Addendum #4

Knott County Transit Facility Rehabilitation and Parking Deck Construction
31 Justice Center Drive
Hindman, KY 41822

ADDENDUM #4

Project: Knott County Transit Facility Project, MGA # 1707
Date: March 22, 2019
Issued by: Allender Contarino, Assoc. AIA – allender@murphygroupky.com

F1 UTILITIES LAYOUT FOR KNOTT COUNTY TRANSIT CENTER
N.T.S.

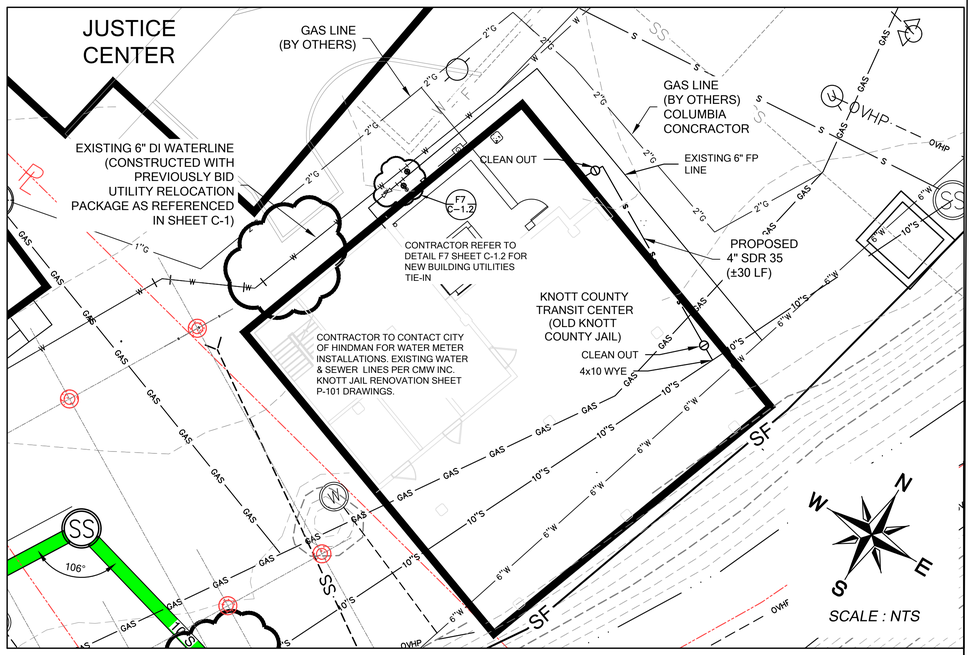
ii. Detail F1 notes to Relocate 6" DI Water Line. (Is this an old note from the previous bid or part of this bid? It is noted to the right of this same detail as a 6" Existing Fire Protection Line, which would have to be relocated by a Sprinkler Contractor. Please clarify.)
Answer: Sheet C-1.2 is noted as being FORE REFERENCE ONLY (Bottom right corner of sheet).

iii. The 4" Sewer is shown to connect directly into the city's 10" Sewer pipe. (Will the City of Hindman allow this or will there have to be a New Manhole set? Please clarify.)
Answer: City of Hindman will allow – please note a 4" clean out is included with the 4"x10" wye fitting - see revised Detail F1/C1.2

△	DATE	NOTES
	3-22-19	Add notes to F1 for Add #4

F7 TIE-IN TO EXISTING 6" FIRE PROTECTION LINE
N.T.S.

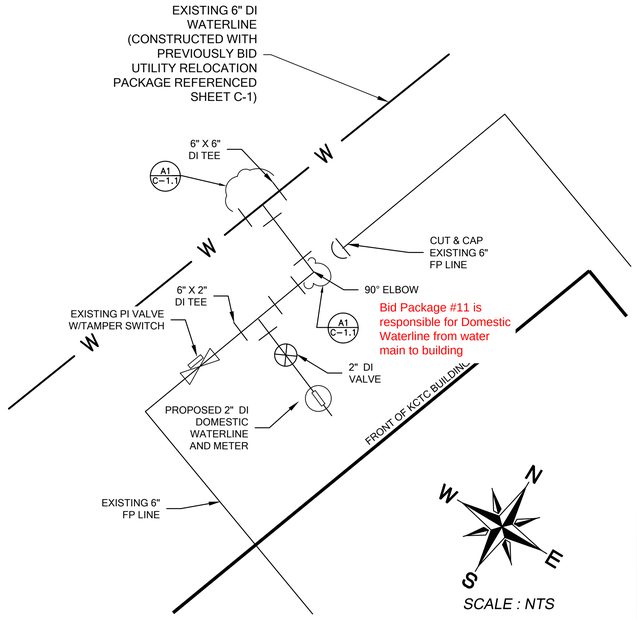
i. The 2" Domestic Water Line is noted on Detail F7 to be Ductile Iron. (The smallest Ductile Iron made is 3". Please clarify new Domestic Water pipe type for Exterior.)
Answer: SDR 17 PVC is acceptable.
